Reference: 12S1395000

23 January 2015

**RE: CENTRAL PARK, BROADWAY – BLOCK 4N STATE SIGNIFICANT  
DEVELOPMENT APPLICATION FOR A MIXED USE BUILDING (SSD 6673)**

Figure 1: Vehicle Swept Path Diagram

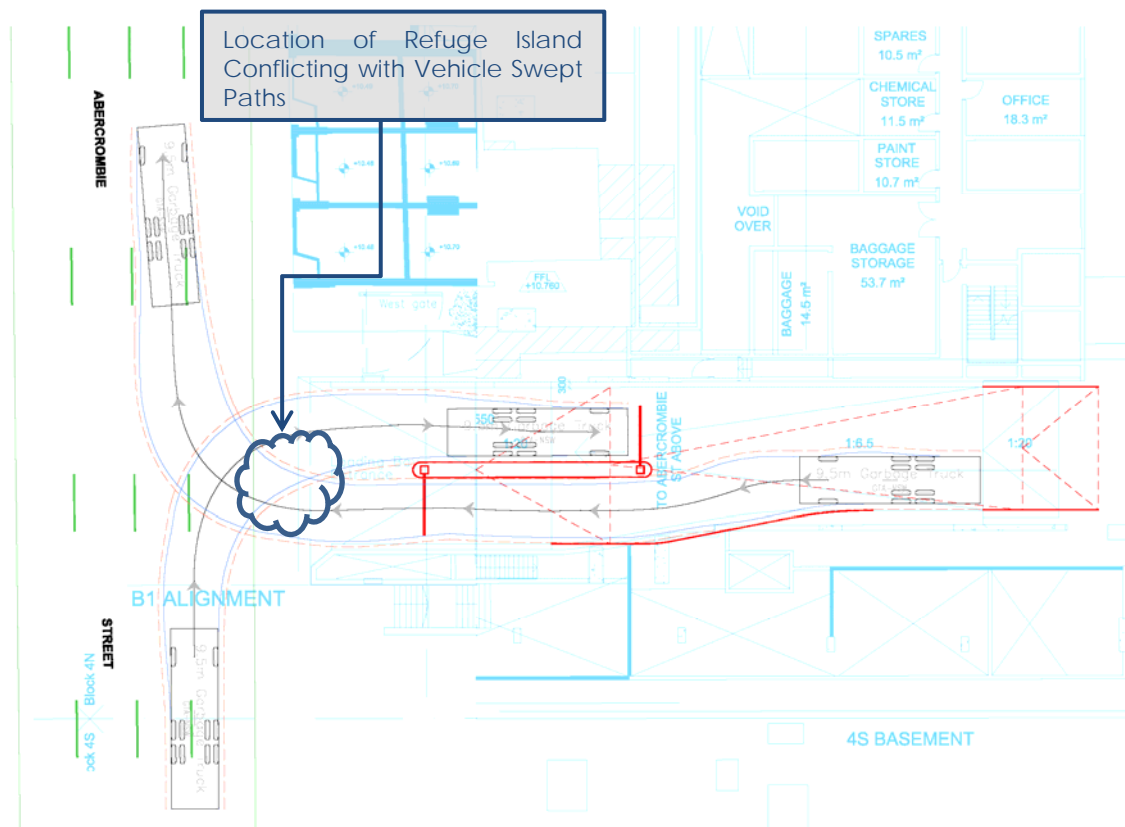
*Further consideration and review of the loading dock driveway access from Abercrombie Street to reduce the width or provide two separate crossings with a pedestrian refuge.*

It is understood that the intent of DPE's comment is to reduce the walking distance for pedestrians across the proposed driveway either in a single crossing movement or in a staged manner by way of a pedestrian refuge island.

It is noted that the current proposed design of the driveway fully complies with Australian Standard AS2890.2:2002. The entry lane has a width of 4.0m while the exit lane has a width of 3.5m. The entry and exit lanes are separated by a 0.8m wide island. The total width of the driveway is 8.3m.

The width of the entry and exit lanes have already been minimised to enable an Australian Standard 8.8m long medium rigid vehicle (MRV) to enter and exit the driveway without conflicting with the design requirements set out in the Australian Standard.

Figure 1 shows the swept paths of a MRV turning into and from the proposed driveway.

The provision of a refuge island without widening the driveway will adversely affect the safety of pedestrians using the refuge island as vehicles turning to and from the driveway would need to overrun the refuge island area. The vehicle swept path diagram shown in Figure 1 also highlights the vehicle swept paths overlapping into where the refuge island would be, if one was to be provided.

Furthermore, it is not practically to widen the driveway without detrimentally affecting the urban and aesthetic design of the building.

Finally, as to whether the proposed width is an acceptable distance for pedestrians to cross, it is noted that the Australian Standard AS2890.2 allows pedestrians to cross an access driveway with a total combined (entry and exit) width of up to 12.5m (Figure 3.1 of AS2890.2) or an entry lane width of 10m and an exit lane width of 10m if separated by a 1.5m wide island (Figure 3.2 of AS2890.2). In this case, the proposed total combined driveway width of 8.3m is significantly less than the requirements set out in the Australian Standard.

In summary, we believe that the proposed pedestrian crossing width is acceptable and could not be made wider to provide a pedestrian refuge without significantly affecting the aesthetic design of the building
